Beaver Valley Power Station, Unit No. 1
Proposed Technical Specification Change No. 208

Beaver Valley Power Station, Unit No. 2
Proposed Technical Specification Change No. 74

Beaver Valley Power Station, Unit Nos. 1 and 2 Proposed Technical Specification Change No. 208 and 74 REVISION OF SPECIFICATIONS 2.1.1, 2.2.1, AND 3.2.5

FIGURE 2.1-1

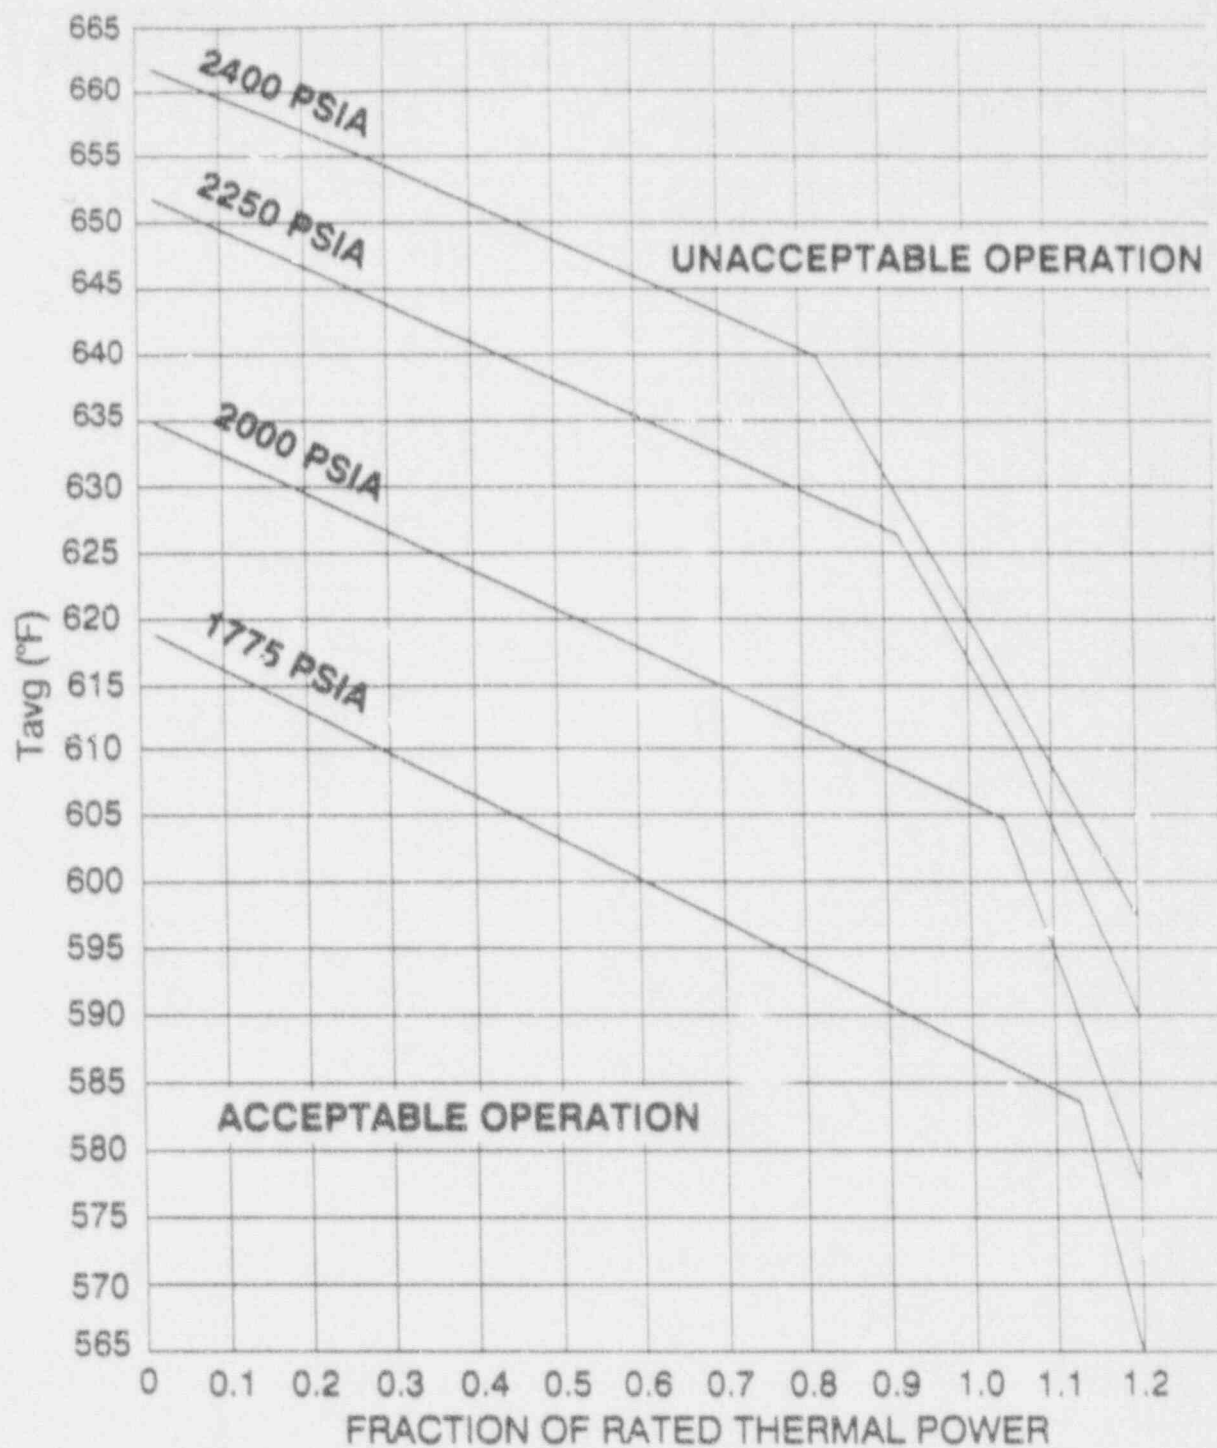
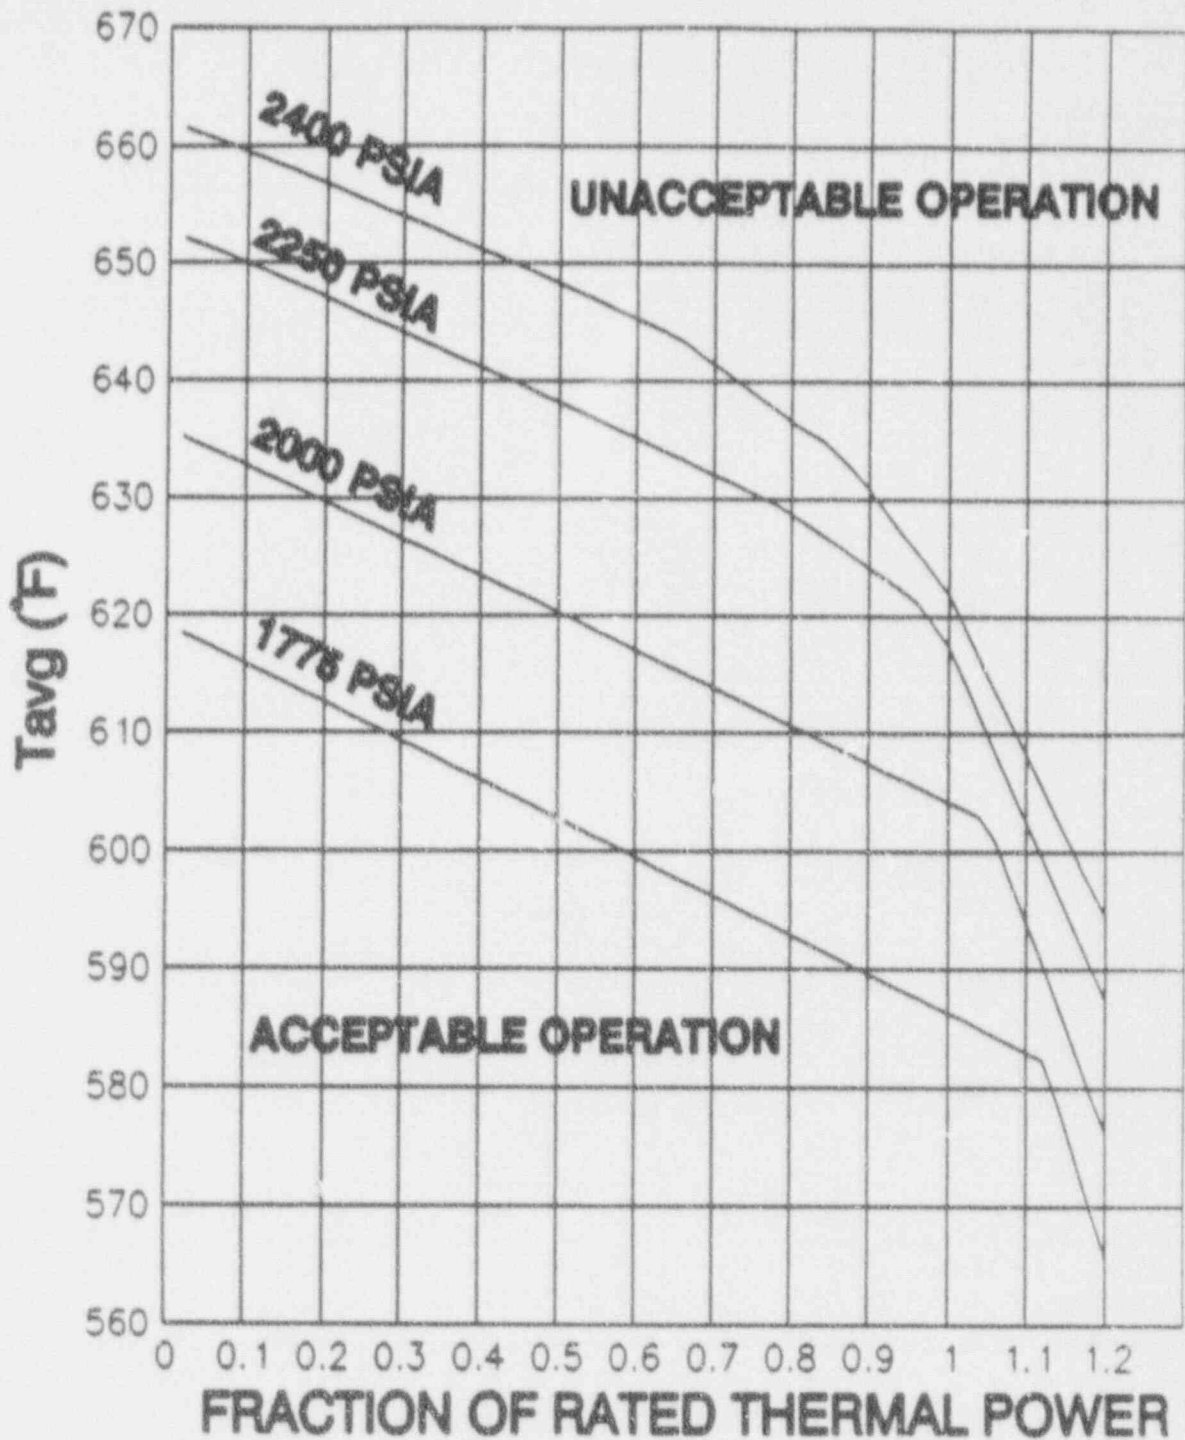
REPLACE WITH
INSERT "B"

For BVPS Unit No. 2, Figure 2.1-1 would be revised to support the 1.5 percent reduction in required RCS total flow. Table 2.2-1 would be revised by changing the value for design flow per loop from 88,500 gpm to 87,200 gpm. Also, the allowable value for table item 12 titled "Loss of Flow" would be changed from 88.8 percent to 88.9 percent. LCO 3.2.5 would be revised by adding a footnote, designated by the number one, pertaining to Table 3.2-1. The footnote would state that the values contained in Table 3.2-1 correspond to analytical limits used in the safety analyses. The existing Surveillance Requirement (SR) 4.2.5.1.1 would be designated by SR 4.2.5.1. The existing SR 4.2.5.1.2 would be deleted. The current footnote designated by a single asterisk would be designated by the number one. Also, this footnote would be modified by changing the reference of Specification 3.0.2 to Specification 4.0.4 and by deleting the words "for the reactor startup following the initial fueling." Table 3.2-1 would be revised by changing the value of RCS Tavg from 580.3°F to 580.2°F. The value for RCS total flow rate would also be changed from 270,850 gpm to 261,600 gpm. The existing footnote, designated by a single asterisk, would be designated by the number one. The footnote, pertaining to flow measurement uncertainty, would be deleted.

The proposed changes to Figure 2.1-1 will be more restrictive by reducing the acceptable operation range for a given Tavg and fraction of rated thermal power. This reduction in the acceptable operation range is necessary in order to ensure analysis limits are met with a reduced TDF.

FIGURE 14D-1
ILLUSTRATION OF OVERTEMPERATURE
AND OVERPOWER ΔT PROTECTION
BEAVER VALLEY POWER STATION-UNIT 1
UPDATED FINAL SAFETY ANALYSIS REPORT

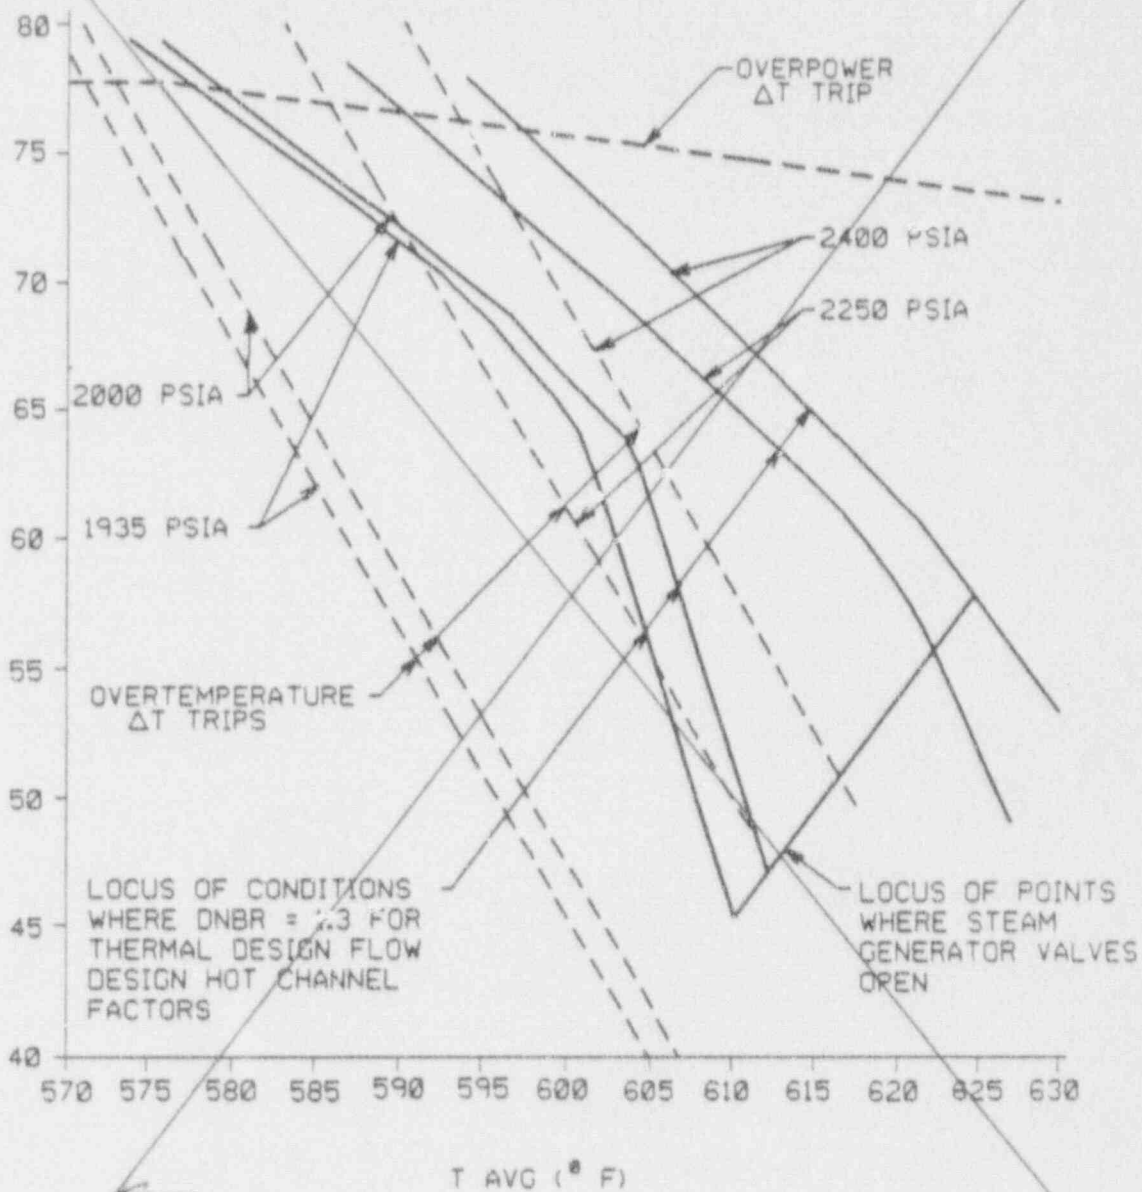
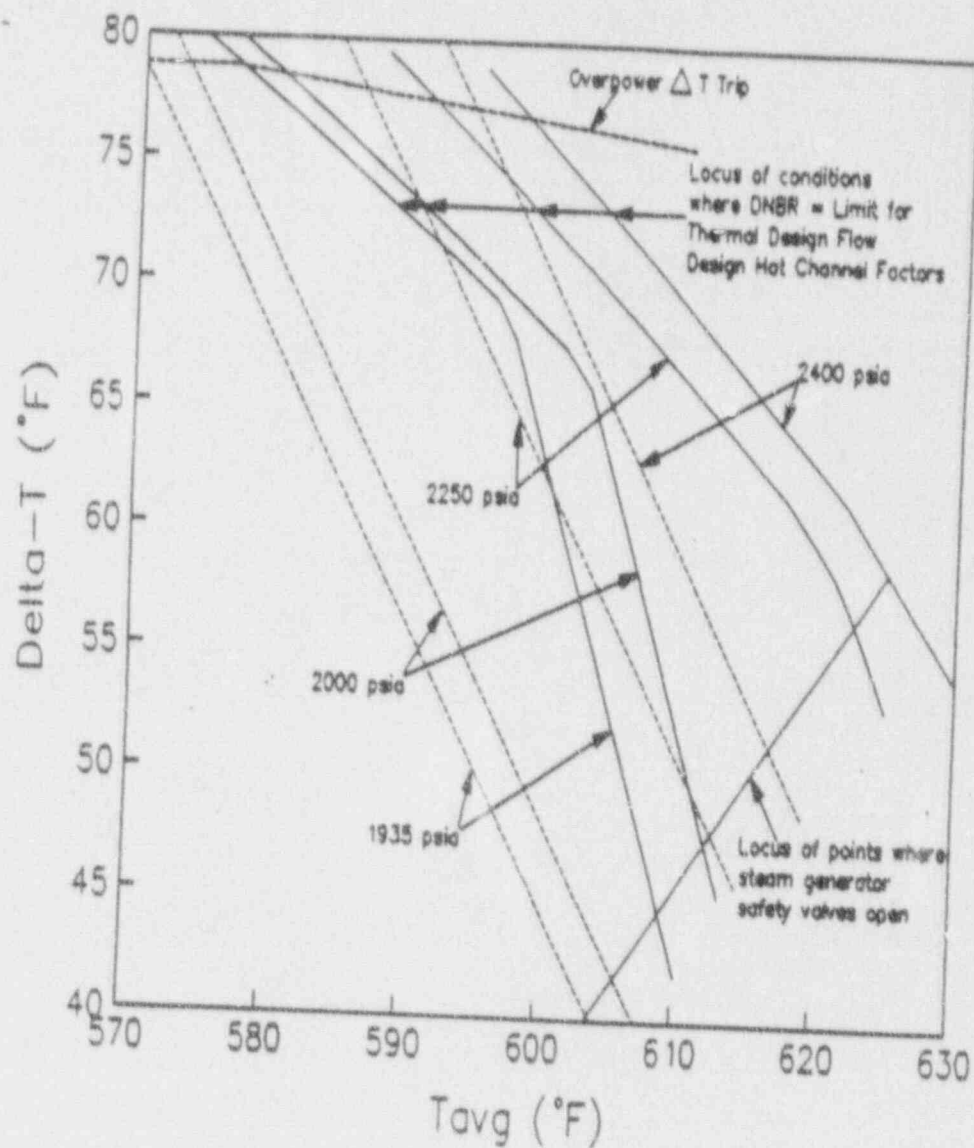
REVISE
WITH
Following Page

FIGURE 15.0-1
ILLUSTRATION OF OVERPOWER
AND OVERTEMPERATURE ΔT
PROTECTION (IN LOOP OPERATION)
BEAVER VALLEY POWER STATION-UNIT 2
FINAL SAFETY ANALYSIS REPORT

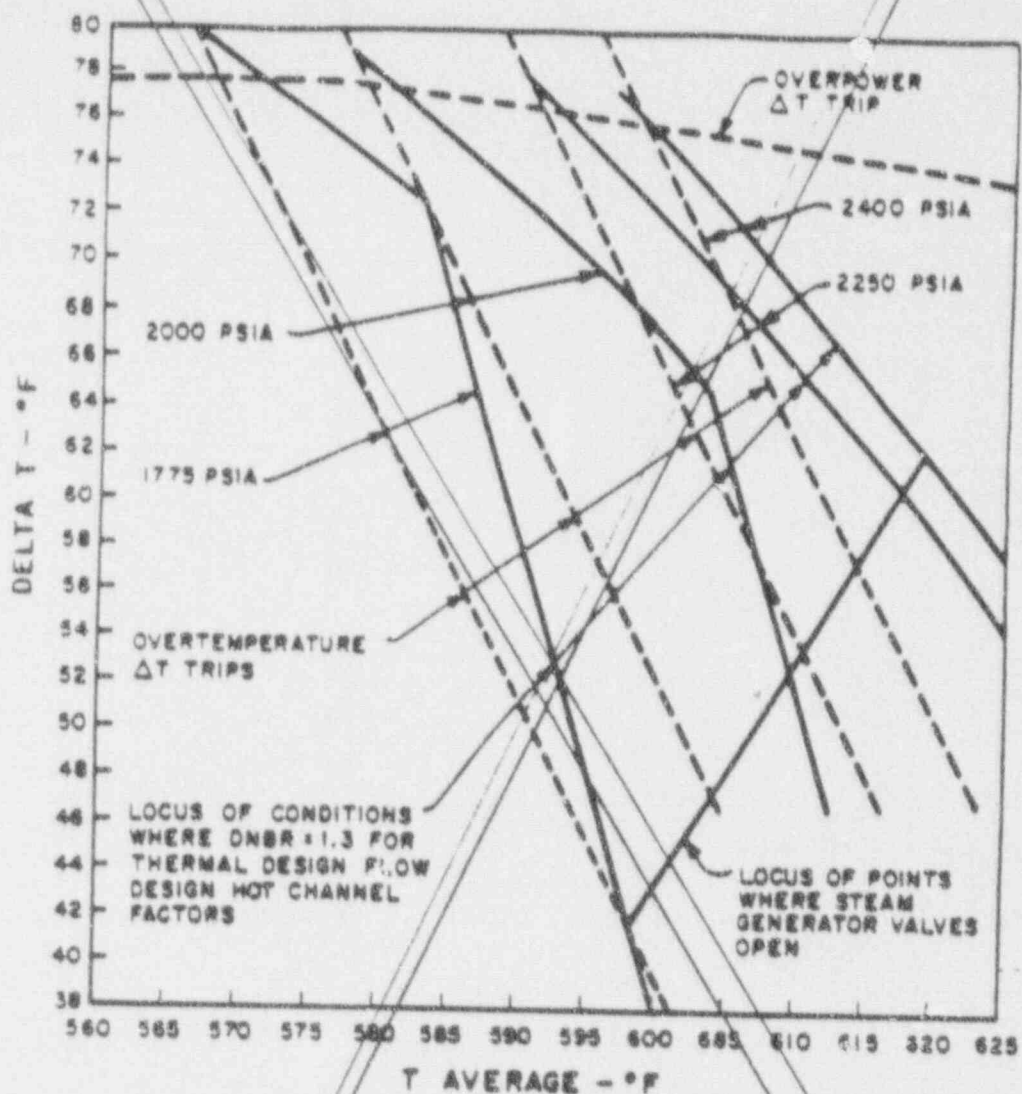
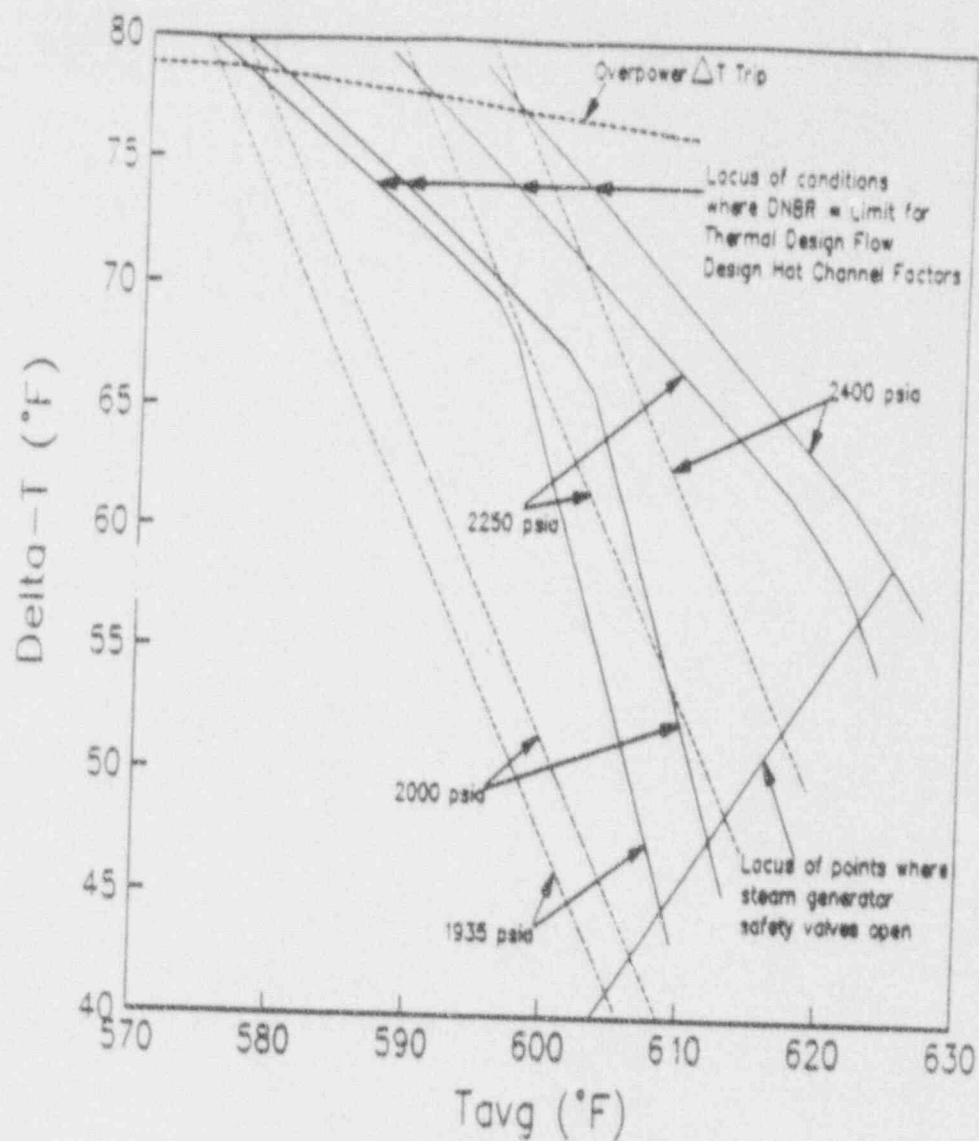
Replace
with following page
